NEW REPLACEMENT KITS FOR 44-020 & 44-033 R2 RELAYS - USED ON AB SERIES DRYERS

FARM FANS

Figure 1. Required wiring connections for revised 11-pin R2 relay base.

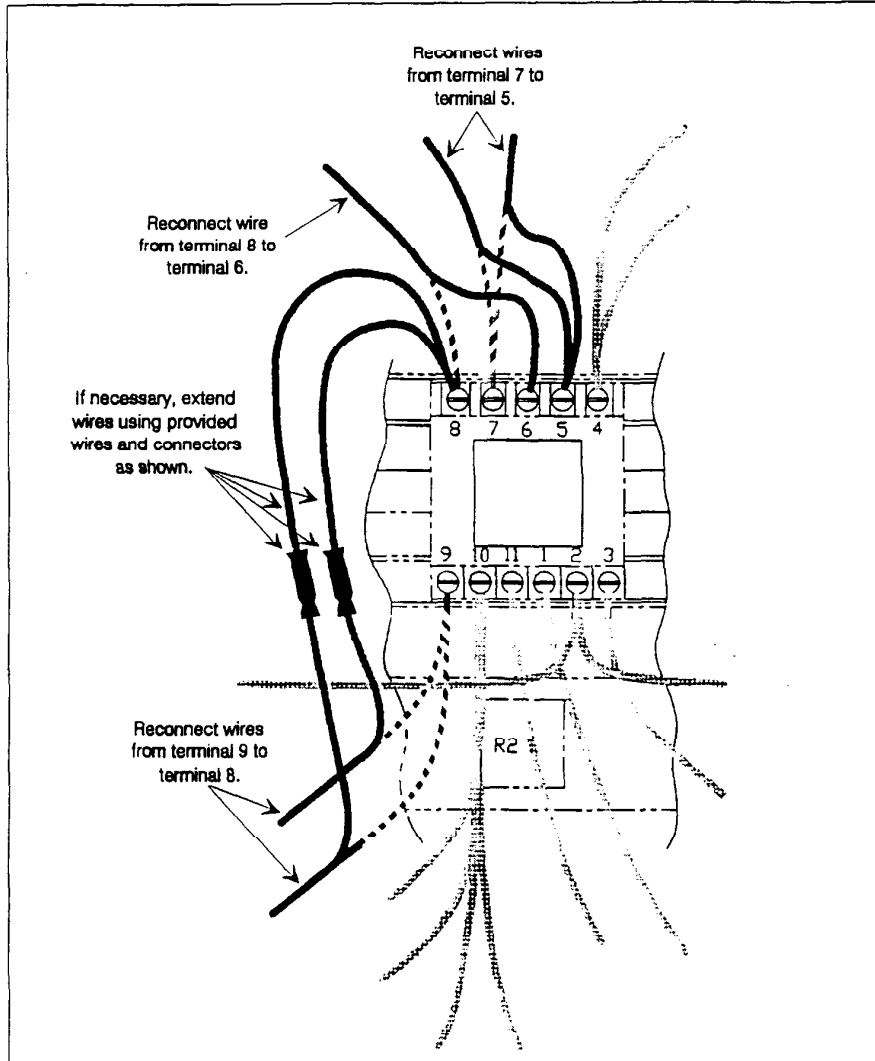
This modification requires that the N.C. contact terminals of the new relay (TDR 056-1675-0) be connected to the original R2 relay base terminals #1 and #4 and the heater terminals to R2 relay terminals #2 and #7 (single fan units) or #10 (double fan units).

1. Remove old R2 relay and insert standard relay into existing R2 relay base.
2. For models with 11-pin R2 relay base only (AB-350A, AB-500A, and AB-18), the relay base must be rewired as shown in figure 1. If necessary, use provided wires and connectors to extend wires leading to base terminal, as shown in figure 1.
3. In most cases the TDR relay with base can be snapped into existing base track. If application permits, mount the TDR relay next to the R2 relay base, shortening wires as needed. Otherwise, place the TDR relay at the end of mounting track. Note that terminal 2 of each base in the mounting track connects to ground by a white wire. A 7" white replacement wire is provided should a longer connector be necessary for terminal 2 of the R2 relay.

Connect the TDR relay leads as follows:

TDR 056-1675-0	Connected To →	R2 Relay Base Terminal
Black	→	#1
Black	→	#4
White	→	#2
Yellow	→	#7 or #10 ¹

¹Terminal #7 applies to AB-120A & AB-180A models. Terminal #10 applies to AB-350A & AB-500A models.

Figure 2. R2 (MBB) Relay Assembly Kit - Models AB-120A, AB-180A, and AB-250A.

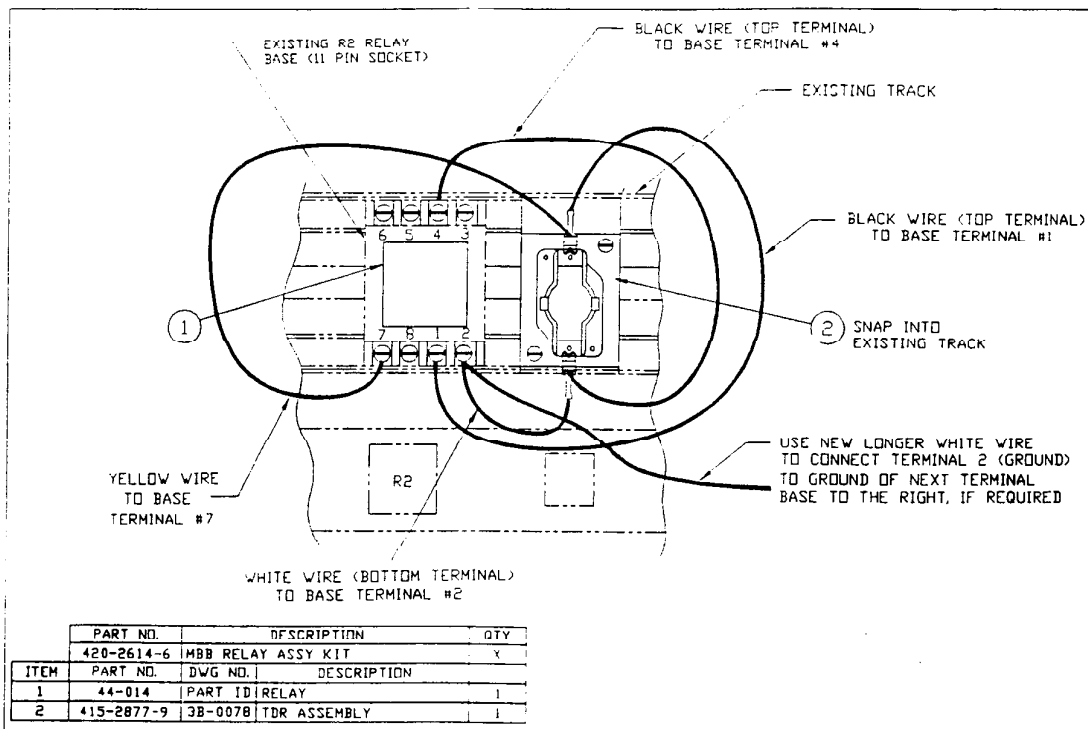
AB-350A, AB-500A, & AB-18B dryers: 11-Pin MBB Relay 44-033 is replaced by 420-2615-3 consisting of: (1) Standard Relay - #056-1864-0 (1) TDR Assembly - #415-2877-9 (1) Wire, brown 10" (2) Wire connectors, butt type (1) Wire, white 7" (1) Instructions (this bulletin)	AB-120A & AB-180A dryers: 8-Pin MBB Relay 44-020 is replaced by 420-2614-6 consisting of: (1) Standard Relay - #44-014 (1) TDR Assembly - #415-2877-9 (1) Wire, white 7" (1) Instructions (this bulletin)	AB-8B & AB-12B dryers: Same as for AB-120A and AB-180A models.
---	--	--

Figure 4. Portion of General Control Circuit showing typical installation of new 8-pin R2 Relay Kit (for single-fan AB models AB-8, -12, -120, -180, and -250).

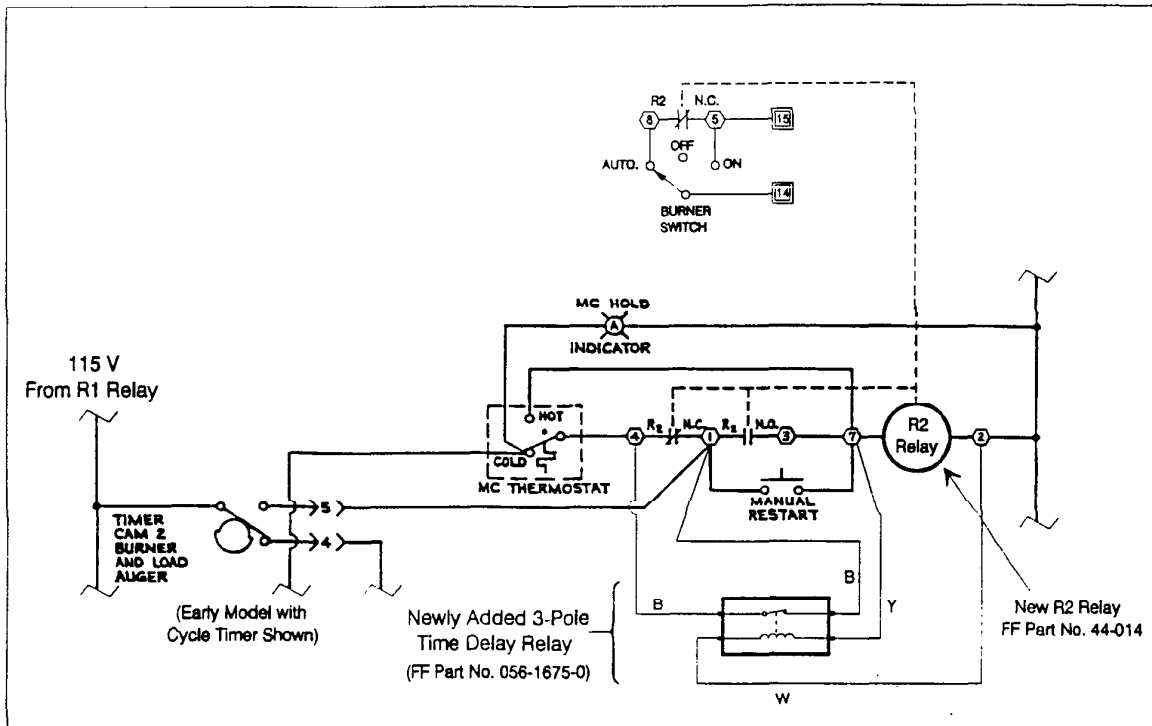
4. See figures 2, 3, and 4 for Relay Assembly Kit diagrams and electrical schematics.
